**Revised draft Amendment No. 5 to AIS-113:- Code of Practice for Type Approval  
of Trailers / Semi-trailers of categories T2, T3 and T4 being towed by Motor  
Vehicles of categories N2 and N3**

**DRAFT AMENDMENT NO. 5-----2019**

**AIS-113: Code of Practice for Type Approval of Trailers / Semi-trailers of categories T2, T3 and T4 being towed by Motor Vehicles of categories N2 and N3**

**Figure-3 :**  
**Vehicle Maneuverability**

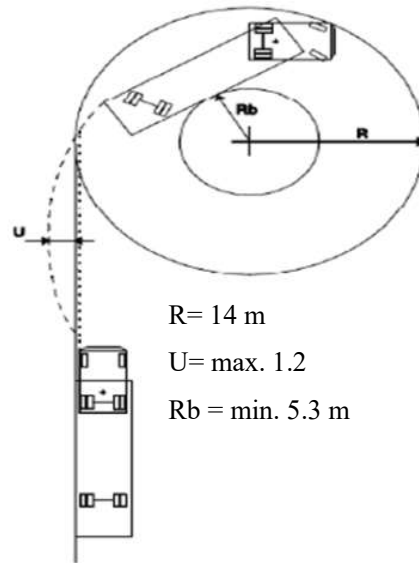
2. Page 13/50, clause No. 8.3.1

Substitute following text and figures for existing text and figure 3 of clause

Tractor-Trailer combination shall comply with the maneuverability requirement, as laid down under clause 5.0 of IS12222:2011 as amended from time to time. Figure 3 shall be referred for TCCD limit. **In case of car carrier trailers, length of canopy shall not exceed 1000 mm in forward longitudinal direction; front taper shall not exceed 30 degree and shall have sufficient clearance above the driver cabin for safe operation on roads.**
